Client:
JANE DAVIES

Project:
ALLEYNE WAY ELMER

Drawing Title:
PROPOSED FLOOR PLANS AND ELEVATIONS

Scale: 1:100	Drawn: V.Botezo	Checked: R. Stefanski	Approved:	Date: Nov. 2017
Job No: 1310	Drawing No: 104	Revision: A

PROPOSED EAST ELEVATION

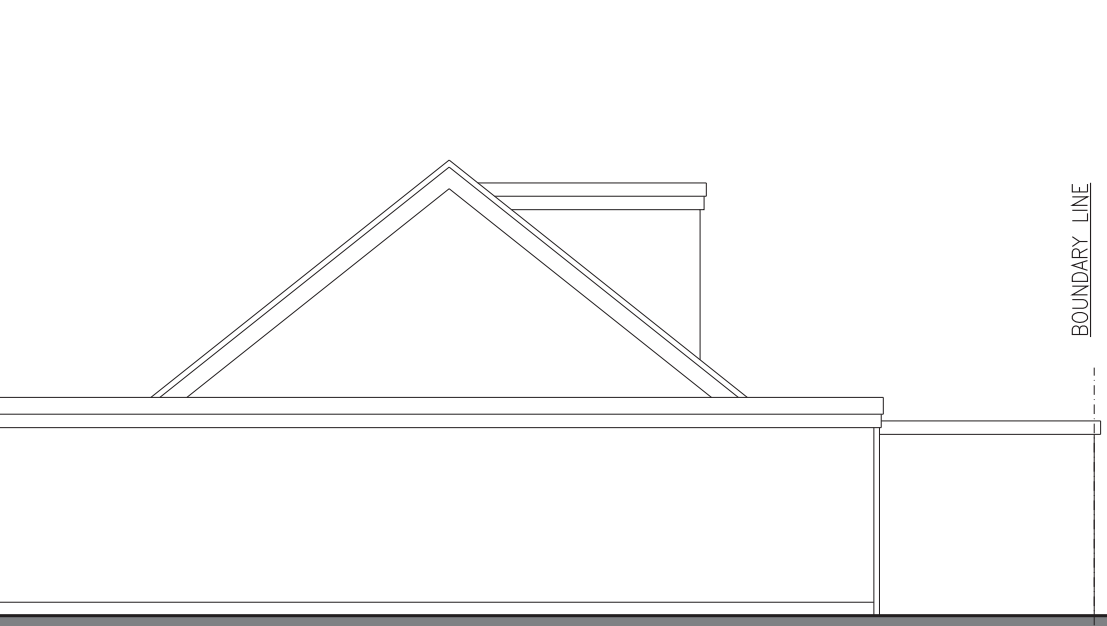
REV A 18.06.18 - EAST ELEVATIONS REVISED TO SUIT PLANNING OFFICERS COMMENTS
